January 11, 2024

Re: Comments on Proposed Renewal of AZPDES Permit (AZ0026387) for Arizona Minerals, Inc.

HYDROGEOLOGY OF HARSHAW CREEK ALLUVIAL DEPOSITS

Figure 1 - Wells along Harshaw Creek from Outfall 002 to Conceptual POC 4

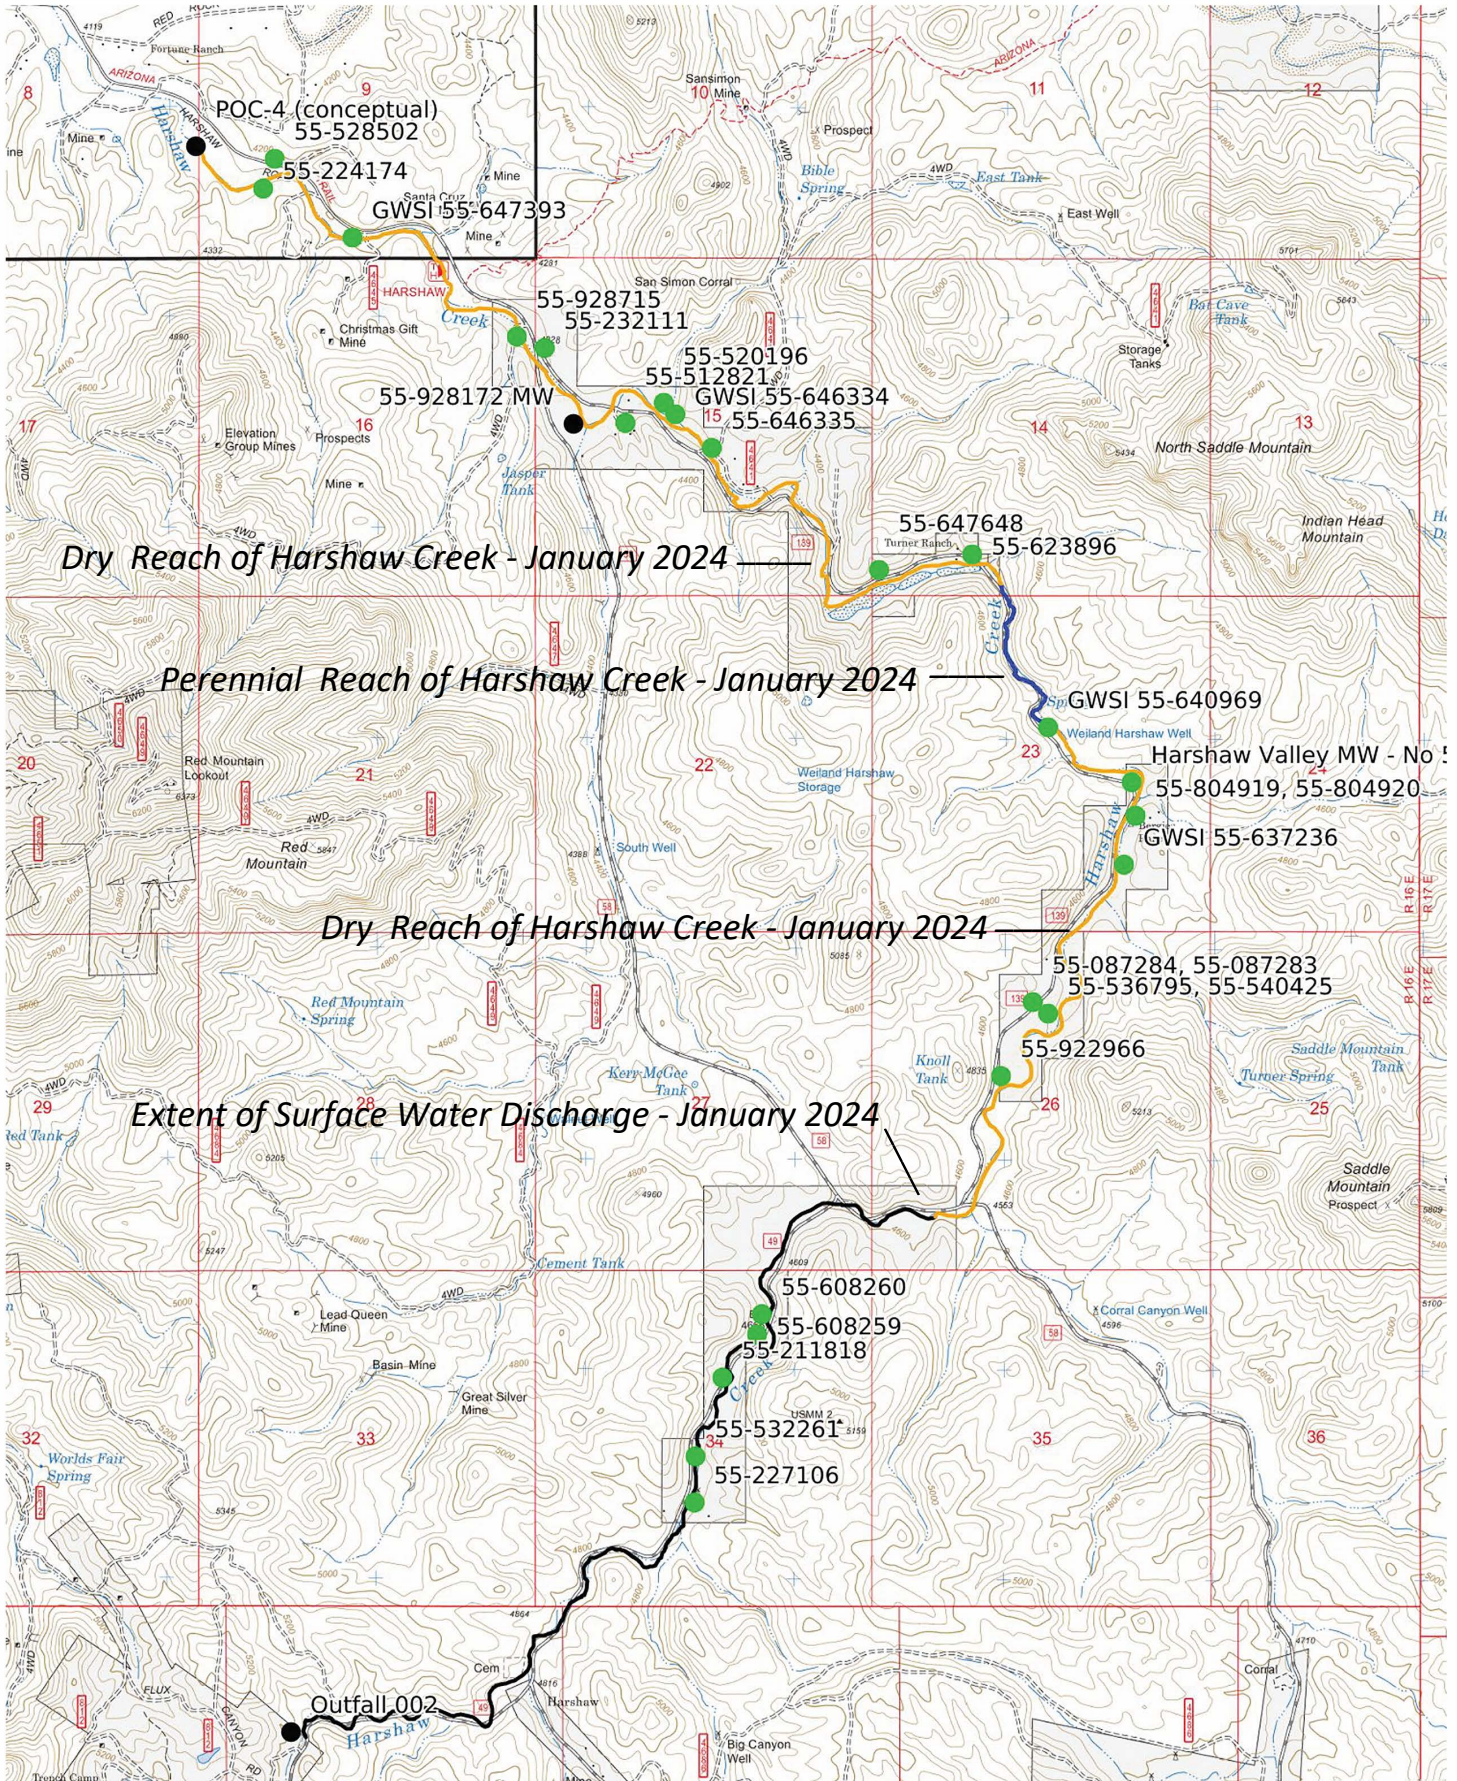
As shown on Figure 1 and in Table 1, there are 33 wells registered with the ADWR from Outfall 002 to conceptual POC 4 including 31 wells for domestic, irrigation and/or stock uses. Based on review of available well construction reports, several of these wells have screened intervals within the alluvium which will be or has been impacted by the discharge as it infiltrates into the groundwater. In wells which have deep screened intervals in finer-grained materials, several of these wells lack annular materials which would prevent the pumping of shallow water impacted by the discharge along the outside of the well.

Based on review of available data including lithology, well construction and water levels, 24 wells (shown in Table 1) along Harshaw Creek from Outfall 002 to conceptual POC 4 are in connection with surface water and will be or are already impacted by contaminants in the discharge which are above drinking water standards.
